Report No. ECCOW613-1408

FIGURE 308.2.1
UNOBSTRUCTED FORWARD REACH

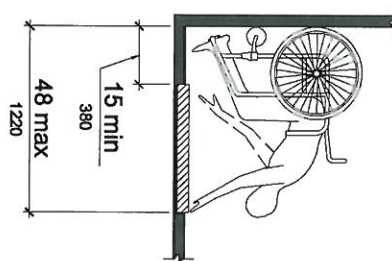
0022	2nd	Hallway	0075	Clothes rod is mounted beyond required reach allowed for approach provided and is mounted at 60" (1524 mm) above the finished floor.	\$308.2.1	Lower or install accessible clothes rod at 48" (1219 mm) max. above the finished floor for forward approach to object (2010 ADA Fig. 308.2.1).	0223	4	In-house	3	\$60.00		
			0076	Shelf is mounted beyond required reach range for approach provided and is mounted at 63" (1600 mm) above the finished floor.	\$308.2.1	Lower or install accessible shelf at 48" (1219 mm) max. above the finished floor for forward (2010 ADA Fig. 308.2.1).	0223	4	In-house	3	\$60.00		
0023	2nd	Classroom	0077	Permanent room identifying signage is mounted on the door leaf.	\$703.4.1	Provide signage on latch side with raised characters and grade 2 Braille, mounted at 48 inches min. measured from the baseline of the lowest tactile character and 60 inches max. from the baseline of the highest tactile character (2010 ADA Fig. 703.4.1).	0224	2	In-house	2	\$30.00

FIGURE 404.2.4.1
MANEUVERING CLEARANCES AT MANUAL SWINGING DOORS AND GATES

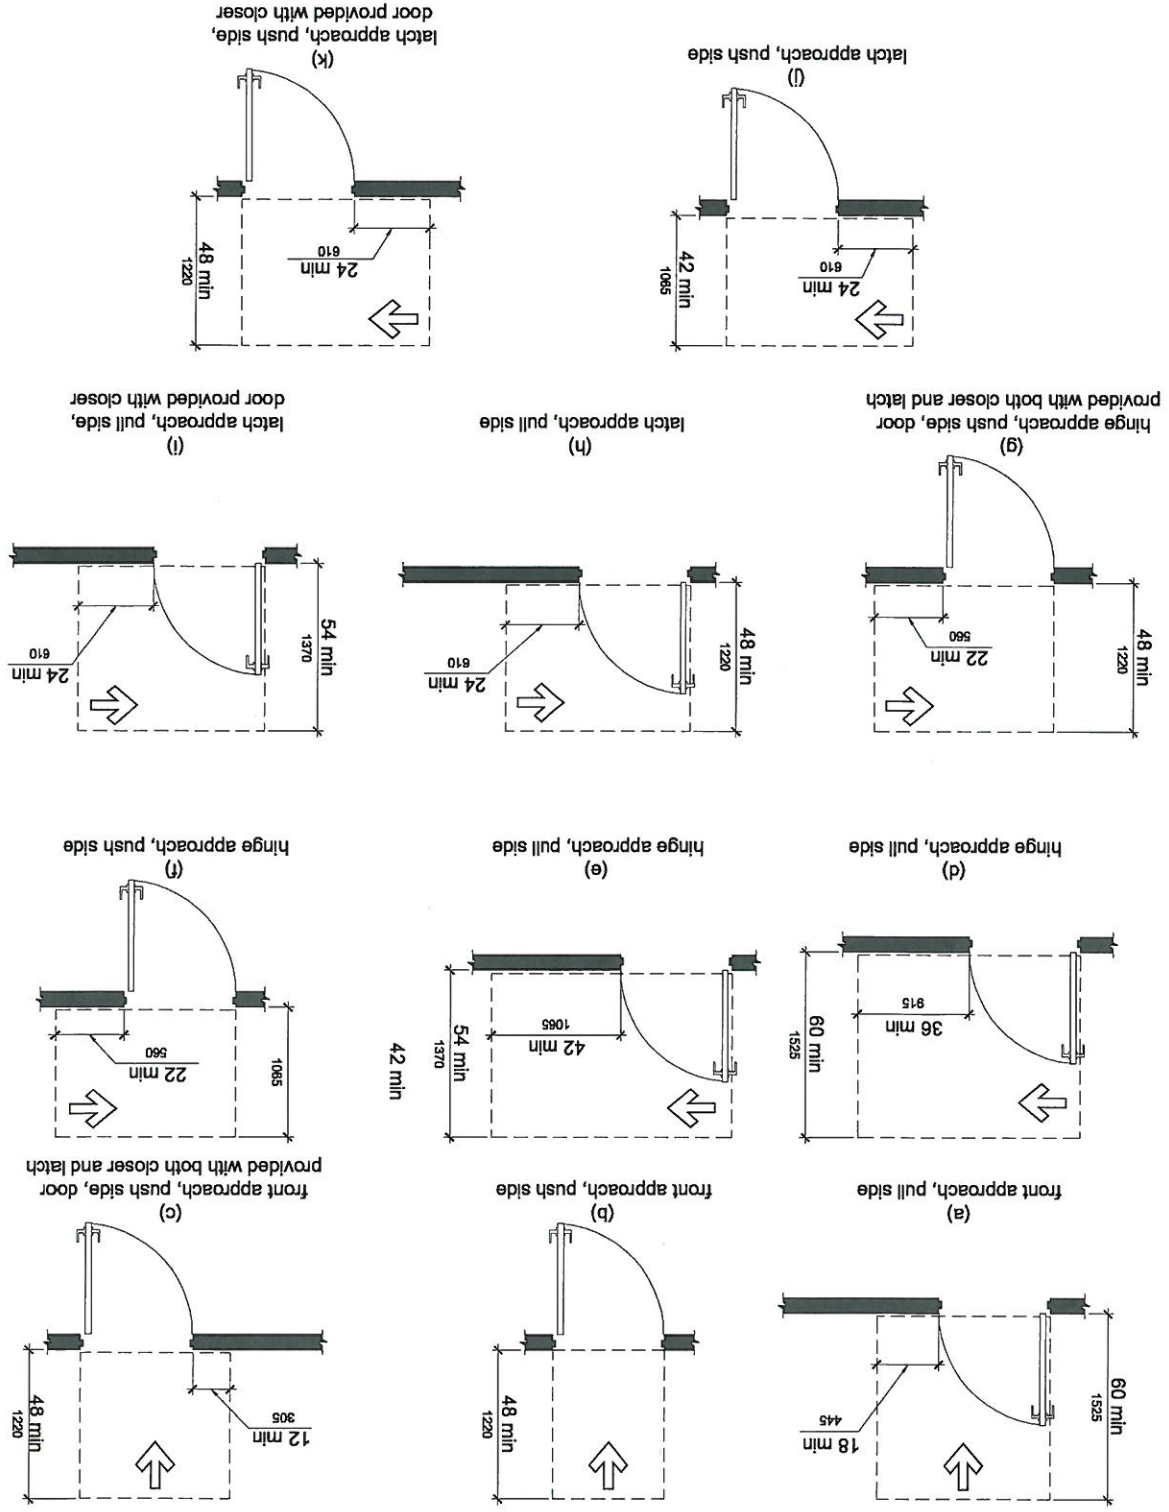
Line	Floor	Room No. Name	Item No.	Physical Obstacle	ADA Code	Method/ Proposed Correction	Photo	Priority	Official Responsible	Schedule	Cost	Status	Comments
			0078	Maneuvering clearance on the pull side of the door is 6.5" (165 mm).	\$404.2.4	Rework door side partition to provide the required 18" (457 mm) min. maneuvering clearance on the pull side of the door beyond the latch side and 60" (1524 mm) min. deep clear floor leveled area with slopes not exceeding 1:48 (2010 ADA Fig. 404.2.4.1).	0225	2	Sub-contractor	2	\$1,185.60		Reverse door swing.
			0079	Door has a non-compliant door opening force of 12 lbf.	\$404.2.9	Adjust or replace door closer, maintain door hinges to provide an opening force not to exceed 5 lbf.	0225	2	Sub-contractor	2	\$275.00		
			0080	Sink is mounted at 37.25" (946 mm) above the finished floor to top of rim.	\$804.4	Relocate and/or mount sink at 34" (863 mm) max. above the finished floor to top of rim.	0227	4	Sub-contractor	3	\$1,891.00

FIGURE 604.2
WATER CLOSET LOCATION

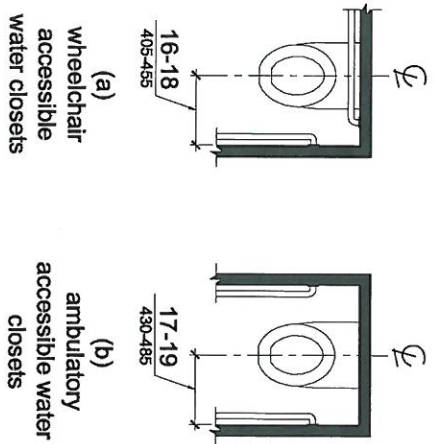
Line	Floor	Room No.	Item No.	Physical Obstacle	ADA Code	Method/ Proposed Correction	Photo	Priority	Official Responsible	Schedule	Cost	Status	Comments
			0067	Water closet is centered at 18.5" (470 mm) from side wall.	\$604.2	Relocate water closet and center between 16" and 18" (406 mm - 457 mm) from side wall (2010 ADA Fig. 604.2).	0216	3	Sub-contractor	3	\$700.00		
			0068	Rear wall and side wall grab bar are mounted at 1.75" (44 mm) clear from the back wall.	\$609.3	Relocate/replace grab bar and mount at 1.5" (38 mm) clear from the back wall (2010 ADA Fig. 609.3).	0216	3	Sub-contractor	3	\$300.00		
			0069	Water closet rear wall grab bar is mounted at 37.25" (946 mm) above the finished floor to the top of the gripping surface.	\$604.5.2	Relocate rear wall grab bar and mount between 33" and 36" (838 mm - 914 mm) above the finished floor to the top of the gripping surface.	0216	3	Sub-contractor	3	\$0.00		Included in item No. 0068.

FIGURE 604.5.1
SIDE WALL GRAB BAR
AT WATER CLOSETS

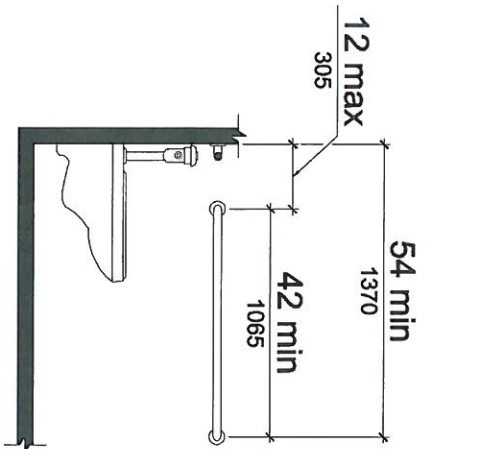
0070	Water closet side wall grab bar is mounted at 36.75" (933 mm) above the finished floor to the top of the gripping surface.	\$604.5.1	Install a 42" (1066 mm) min. long side wall grab bar at 54" (1371 mm) min. from rear wall to centerline of outer flange and mount at 33"-36" (838 mm - 914 mm) above the finished floor to the top of the gripping surface (2010 ADA Fig. 604.5.1)	0216	3	Sub-contractor	3	\$0.00		Included in item No. 0068.
			0071	Trash can encroaches over the water closet clearance.	\$604.3.2	Relocate encroaching item to provide the required 60" by 56" (1524 mm by 1422 mm) min. clearance at water closet (2010 ADA Fig. 604.3.1).	0216	3	In-house	3	\$30.00		
0019	2nd	Shine Office	0072	Furniture encroaches over maneuvering clearance on the pull side of the door.	\$404.2.4	Relocate encroaching item to provide the required 18" (457 mm) min. maneuvering clearance on the pull side of the door (2010 ADA Fig. 404.2.4.1).	0218	2	In-house	2	\$30.00

FIGURE 703.4.1
HEIGHT OF TACTILE CHARACTERS
ABOVE FINISH FLOOR OR GROUND

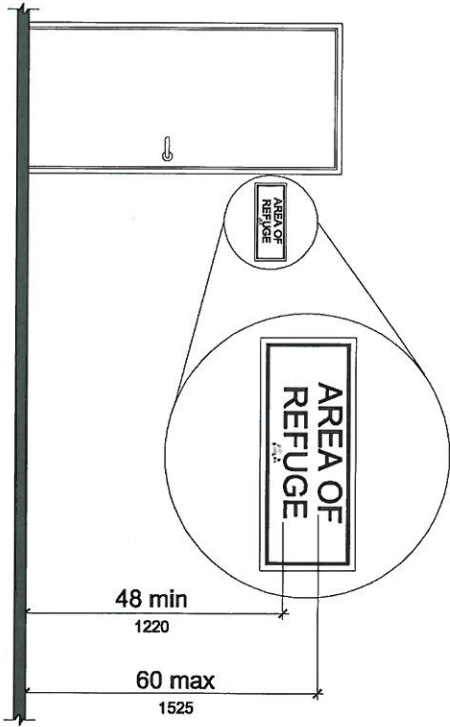
Line	Floor	Room No. Name	Item No.	Physical Obstacle	ADA Code	Method/ Proposed Correction	Photo	Priority	Official Responsible	Schedule	Cost	Status	Comments
0020	2nd	Computer Room	0073	Permanent room identifying signage is mounted on the door leaf.	\$703.4.1	Provide signage on latch side with raised characters and grade 2 Braille, mounted at 48 inches min. measured from the baseline of the lowest tactile character and 60 inches max. from the baseline of the highest tactile character (2010 ADA Fig. 703.4.1).	0219	2	In-house	2	\$30.00		
0021	2nd	Conference Room	0074	Permanent room identifying signage is mounted on the door leaf.	\$703.4.1	Provide signage on latch side with raised characters and grade 2 Braille, mounted at 48 inches min. measured from the baseline of the lowest tactile character and 60 inches max. from the baseline of the highest tactile character (2010 ADA Fig. 703.4.1).	0222	2	In-house	2	\$30.00

0024	2nd	Activity Room	0081	Permanent room identifying signage is mounted on the door leaf.	\$703.4.1	Provide signage on latch side with raised characters and grade 2 Braille, mounted at 48 inches min. measured from the baseline of the lowest tactile character and 60 inches max. from the baseline of the highest tactile character (2010 ADA Fig. 703.4.1).	0228	2	In-house	2	\$30.00		
			0082	Sink is mounted at 36" (914 mm) above the finished floor to top of rim.	\$804.4	Relocate and/or mount sink at 34" (863 mm) max. above the finished floor to top of rim.	0230	4	Sub-contractor	3	\$1,891.00		
0025	Basement	Accessible Putting Green	0083	Access to the putting green has a 0.5" (13 mm) vertical change in level.	\$303.2	Rework area and provide a 0.25" (6 mm) max. vertical change of level, with a slope no greater than 1:2 (2010 ADA Fig. 303.2).	0235	4	Sub-contractor	3	\$300.00
